MISCELLANEOUS CORRESPONDENCE ZONE K SOLID WASTE MANAGEMENT UNIT 44
(SWMU 44) AND OTHER SITES CNC CHARLESTON SC
4/1/2001
CNC CHARLESTON

Correspondence Apr 01
CNC.

RCRA Interim Measures Workplan
Solid Waste Management Area 42, Zone A
Revision 0, Dated 23 January 2001

200'
June 1947
1" = 100'

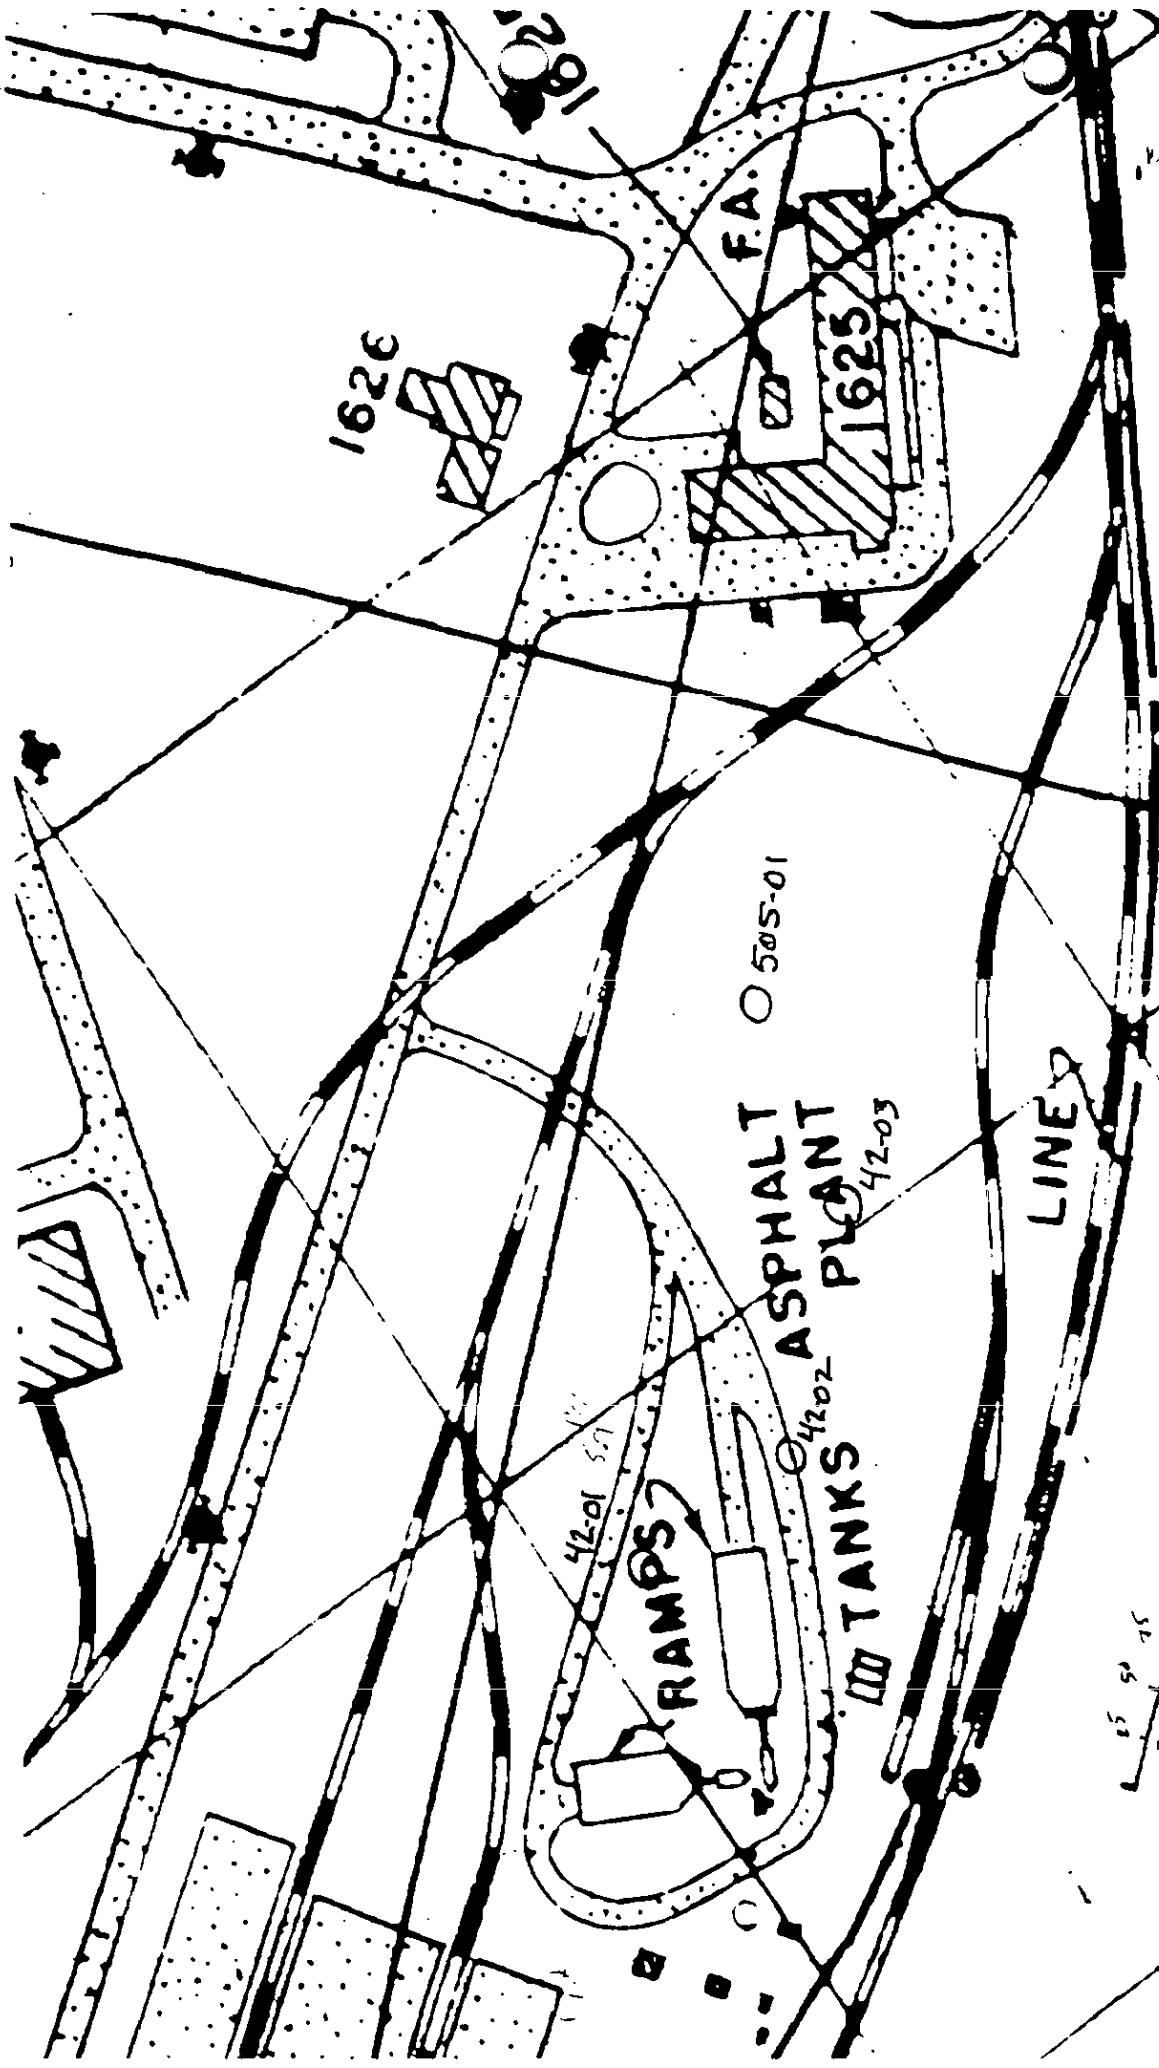
- The Department recently received maps of the Charleston Naval Base dated January 1962 and June 1947. These maps indicate that the SWMU 42 Asphalt Plant may be in a location different from the site that is depicted in the RFA or RFI. This information, when coupled with site groundwater elevation contour maps, indicates that the shallow RFI monitoring wells may be up gradient or side gradient of the site they were intended to assess. Copies of the relevant maps with the current monitoring wells drawn in and Figures of groundwater elevations are provided with these comments.

Figure 5.1 - Shallow Wells
 High Tide 8-7-96
 CMS WP
 Ensaf

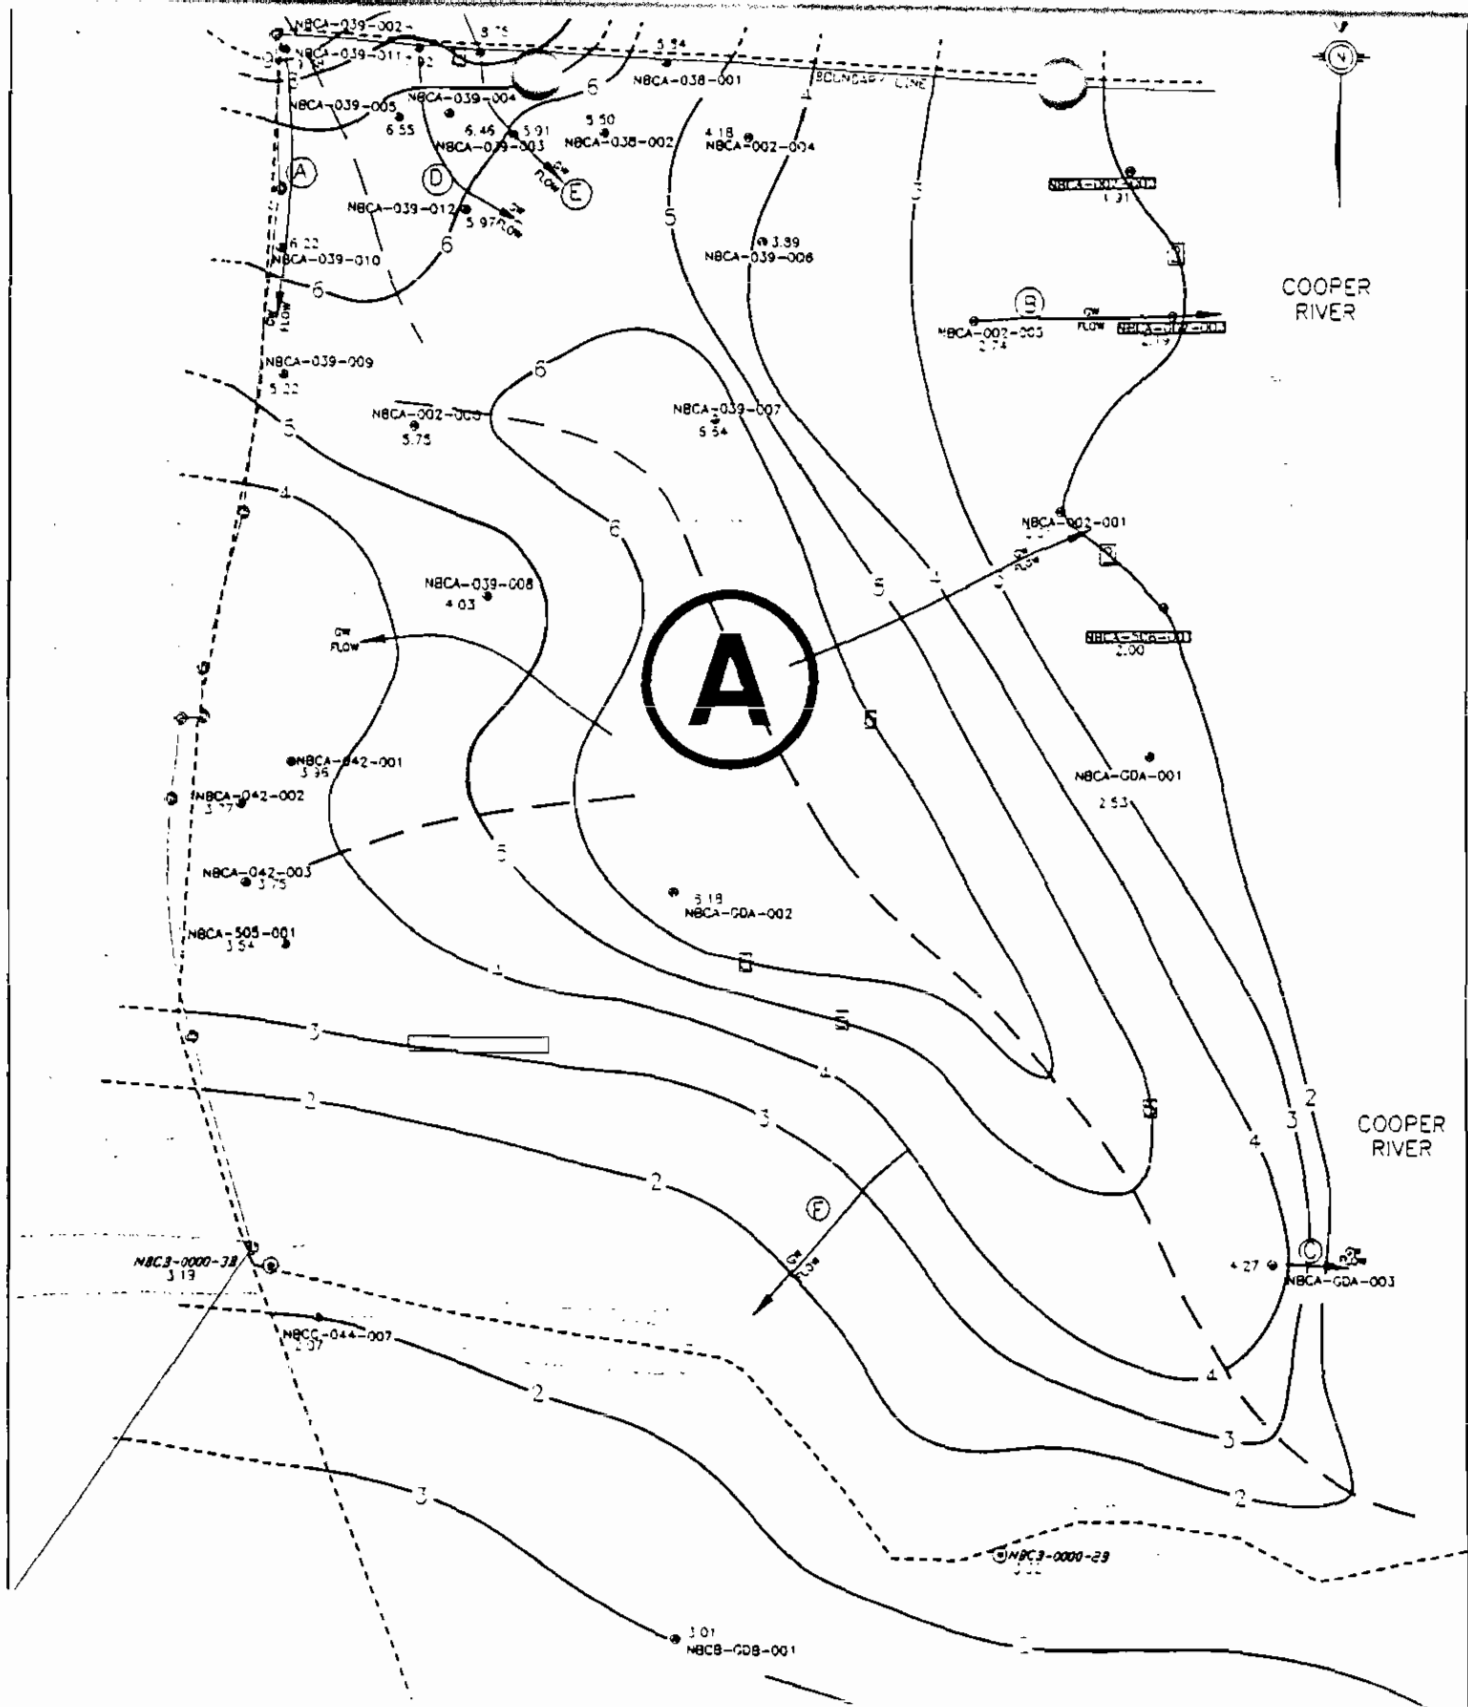
- The shallow monitoring wells 042001 and 505001 reported low ppb detections of chlorinated solvents in excess of RBCs and/or MCLs. It is not clear whether these shallow groundwater detections are the edge of a larger and deeper downgradient contaminant plume. Copies of the Groundwater Elevation Contours from the Ensafe CMS Workplan are provided with these comments.
